ADDENDUM NO. 1

Project Name:	Charlottesville-Albemarle Airport Mechanical Systems Upgrades
RS&H Project Number:	20541892009

DATE OF ISSUANCE: June 28, 2024

SHEET ID:
MD101

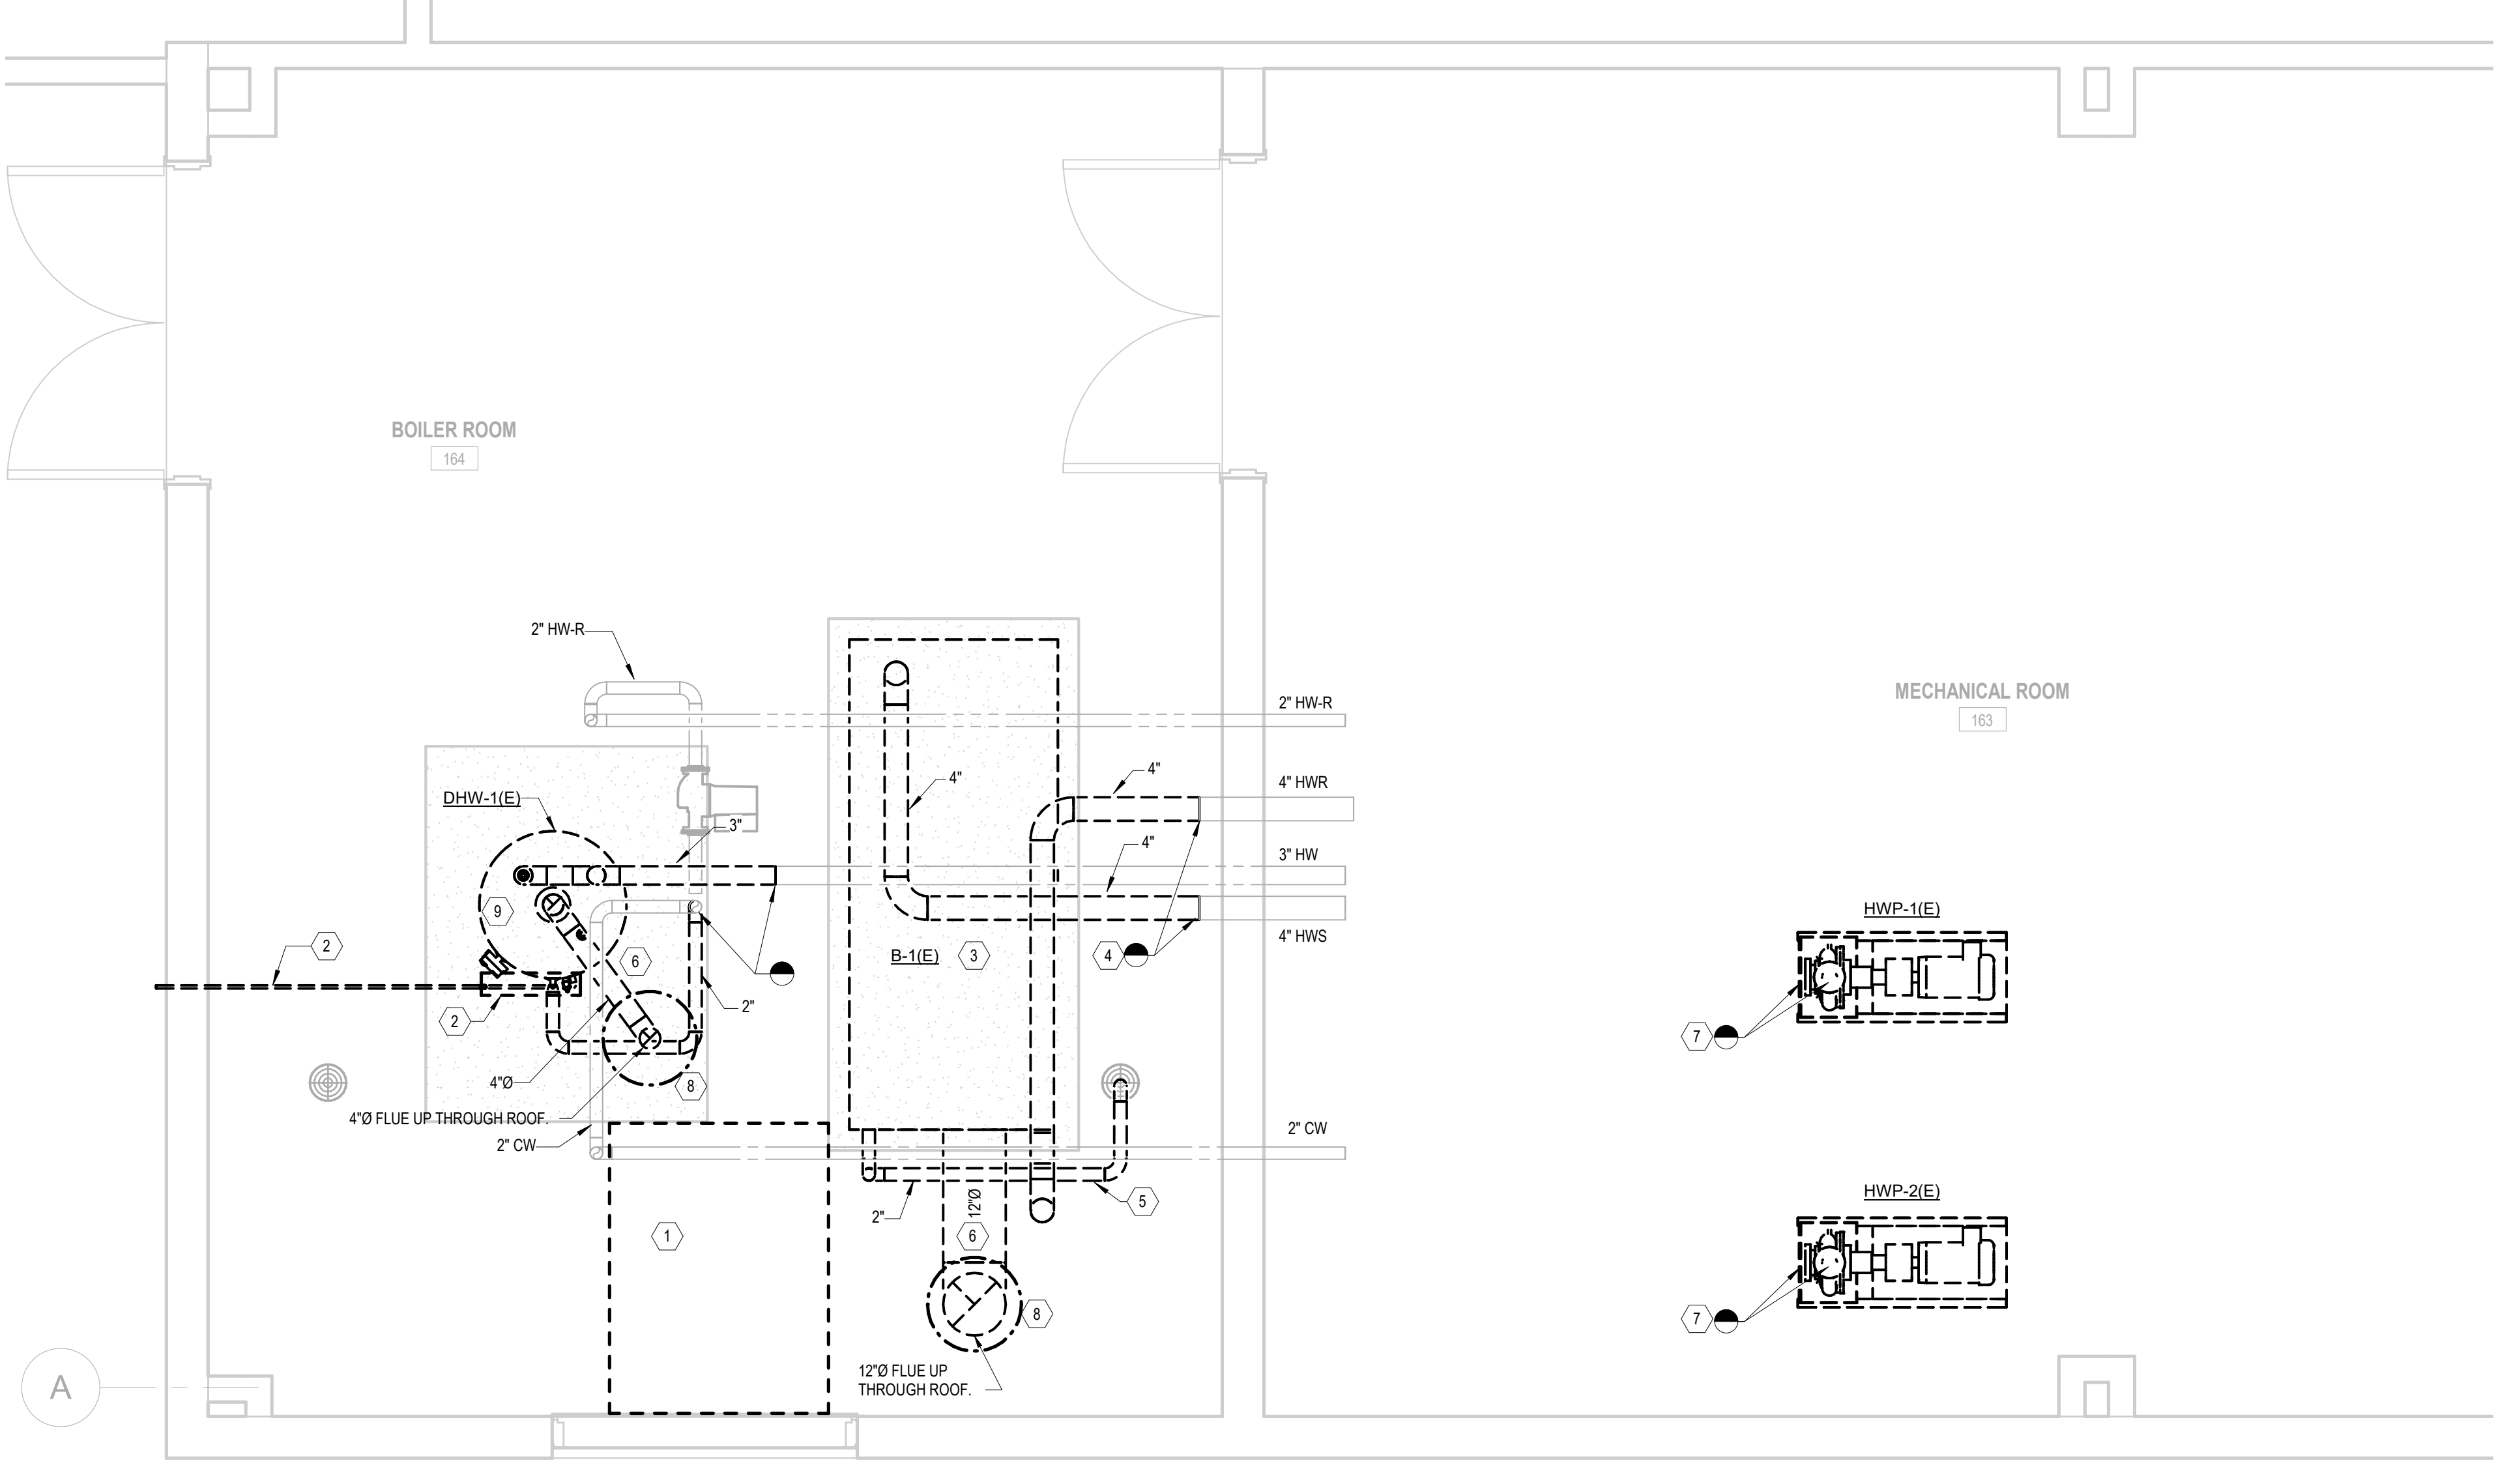
34	Regarding MD101: Please confirm that the mechanical room will be clear of non-essential stored items prior to work beginning?	All non-essential stored items in the mechanical room, will be removed by the airport prior to the start of on-site activities in the mechanical room.
35	Regarding MD101 Note #2: Please confirm whether the capping of propane system is to be done at the exterior or interior wall of the boiler room? Please confirm if a ball valve is required prior to the cap.	Propane system is existing to be demolished. Cap piping at interior of wall. Ball valve is not required prior to cap.
36	Please confirm what gas train is to be supplied on the boiler? (ex. UL, IRI, or FM) .	The basis of design equipment complies with FM Global 6-4 requirements.
37	Regarding the gas fired boiler schedule: please confirm the gas pressure is 14 inches w.c. (not psi).	Correct. The pressure is to be 14 inches W.C.
